Ref/Job No: 13GOSBUS-0034

8 May 2015

RE: Kembla Grange Waste Resource Recovery Facility, 50 Wylie Road, Kembla Grange (S14/0039)

ATTACHEMENT 2 - REVISED SITE PLAN

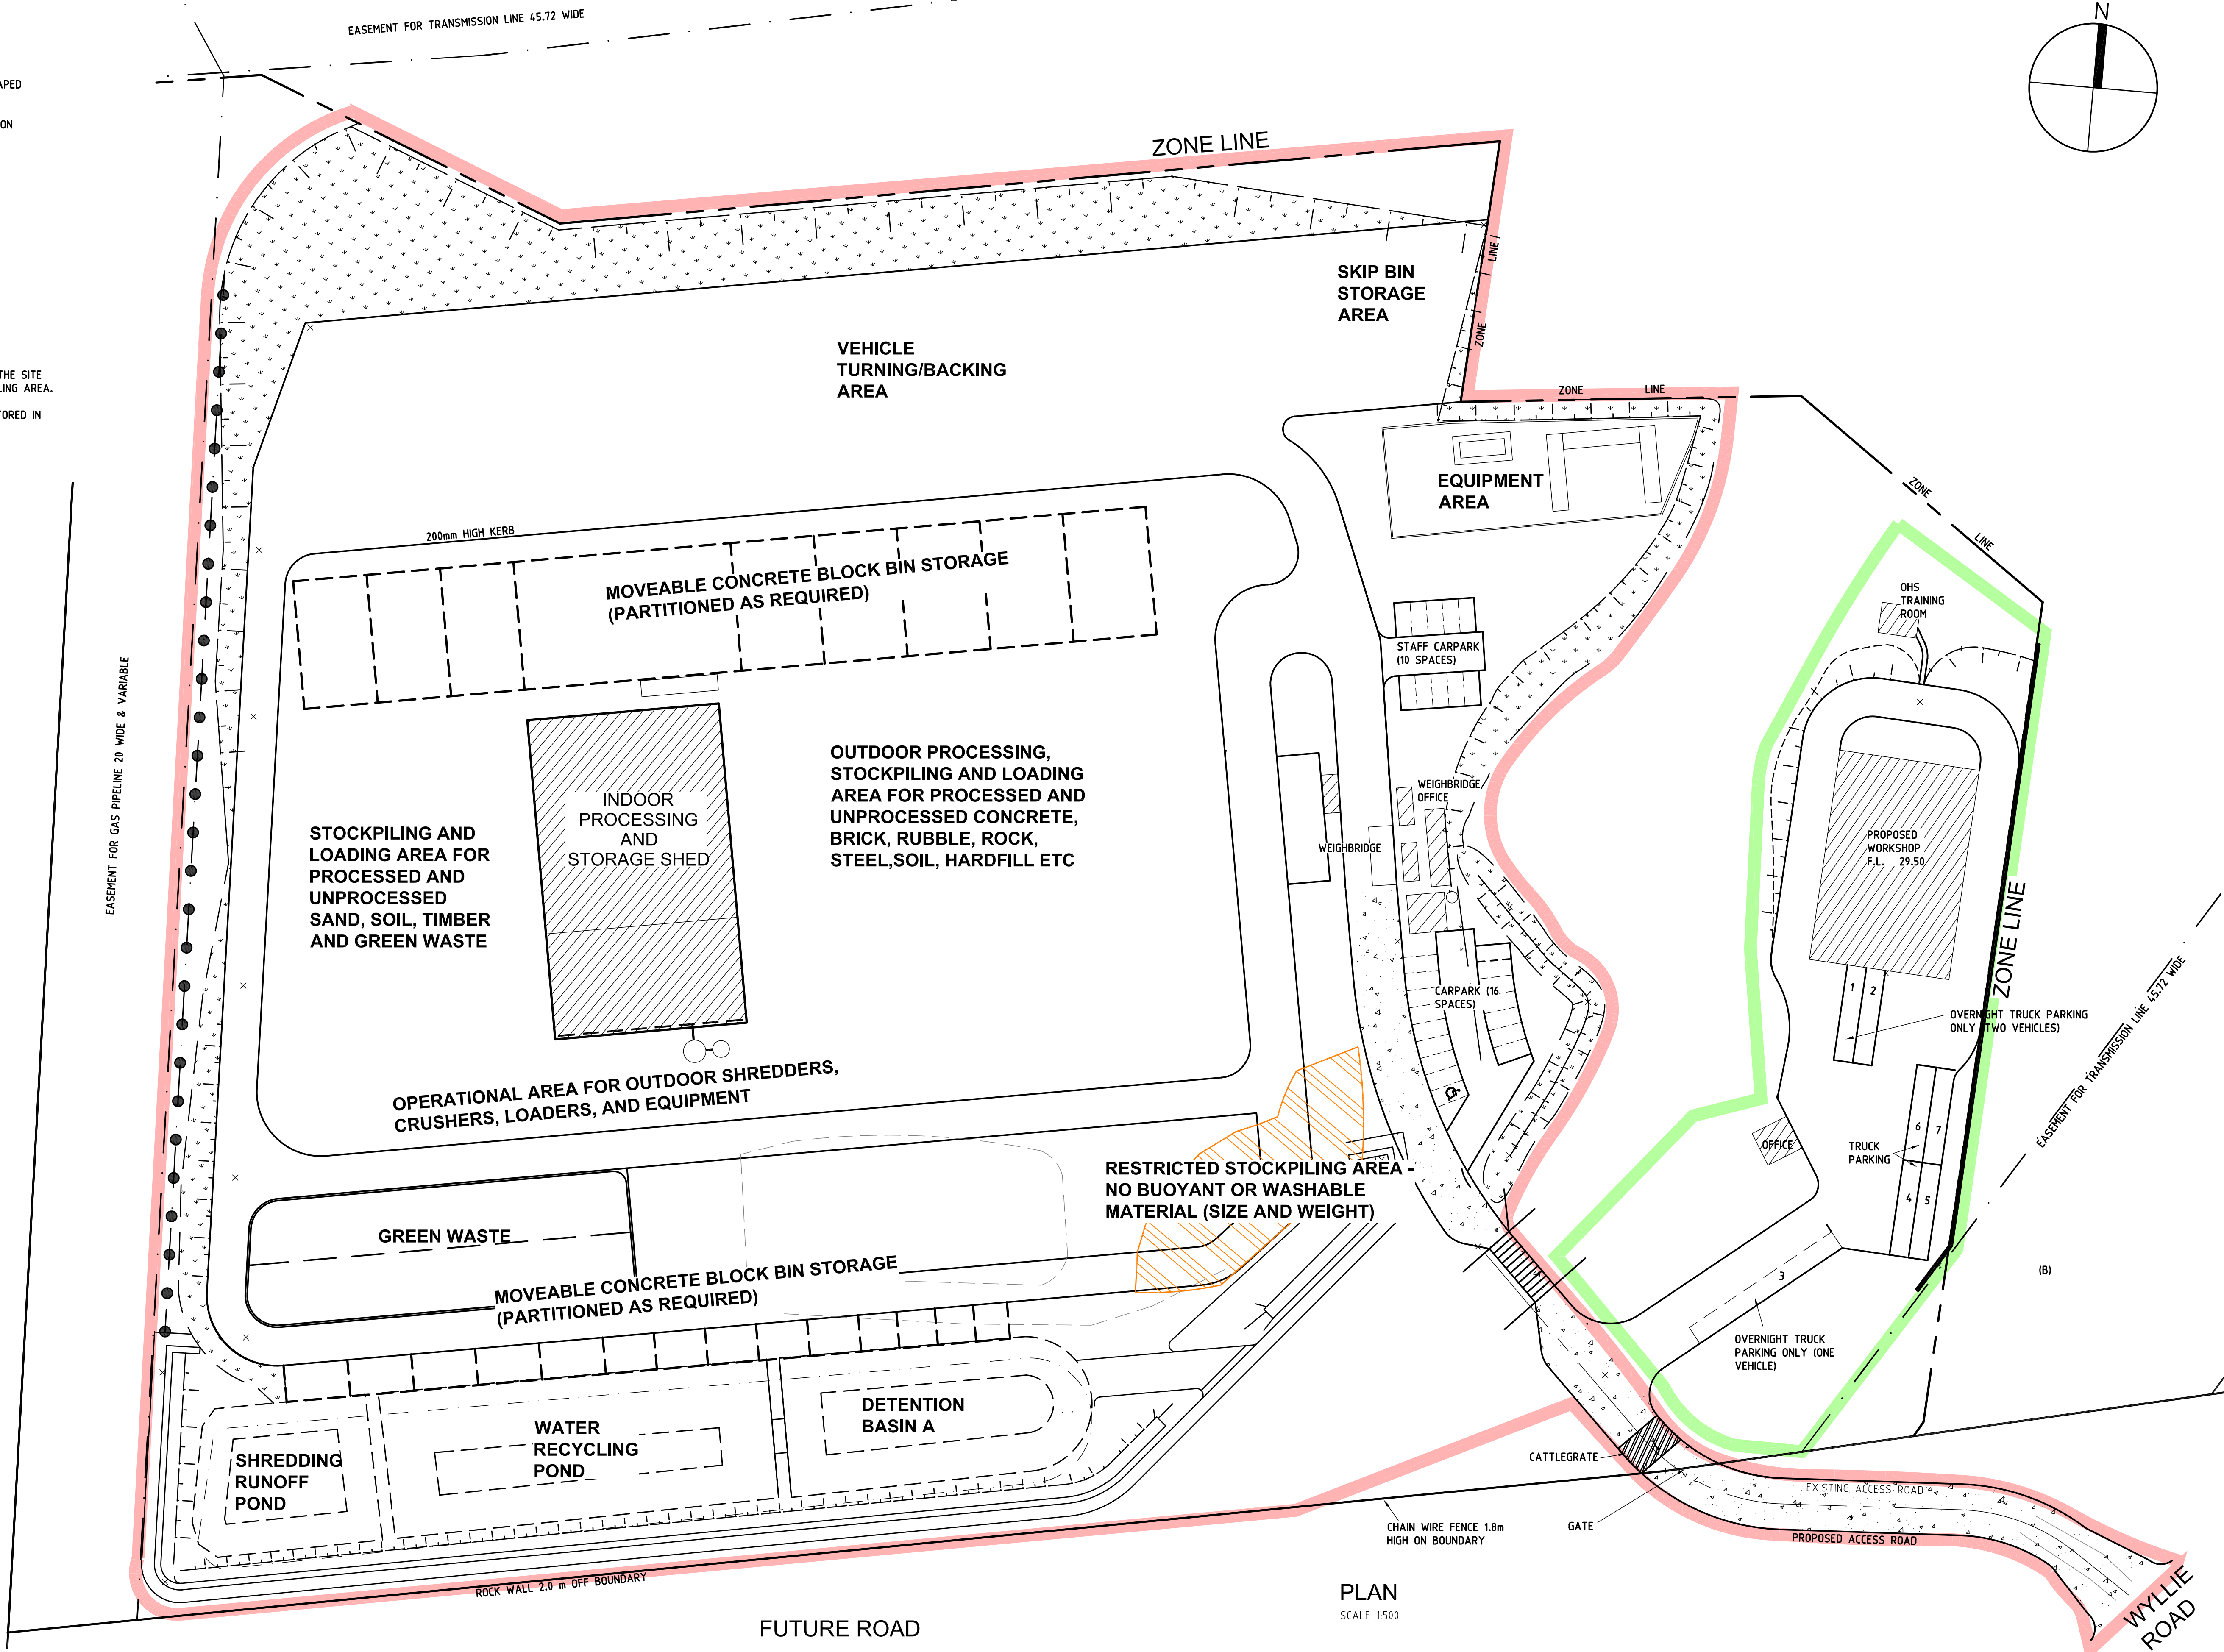
The recommended 100 m APZ is viewed to be excessive for the nature of the proposal and the level of bushfire risk to and from the site. Notwithstanding this, the site plan has been amended (Attachment 2) to confine the loading, stockpiling and processing stages of the combustible waste to more than 100 m from the riparian zone to the east as follows:

- Stockpiling and loading area for green waste and timber to be confined to the western and south-western sides of the 'Indoor Processing & Storage Shed' over 100 m from the riparian area, and
- 'Indoor Processing & Storage Shed' will house other combustible waste over 100 m from the riparian area.

Requested plan attached. It clearly marks the location of storage/stockpiles – of which the combustible ones (greenwaste, timber and rubbish) are either in the shed or to the west of it, being 100m from the riparian zones to the east.

A	NOTES RE STOCKPILING AND LOADING AREAS AMENDED	01-05-2015	A.P.	W.M.
Revision	Amendment or reason for issue	Issue date	Drawn by	Authorised
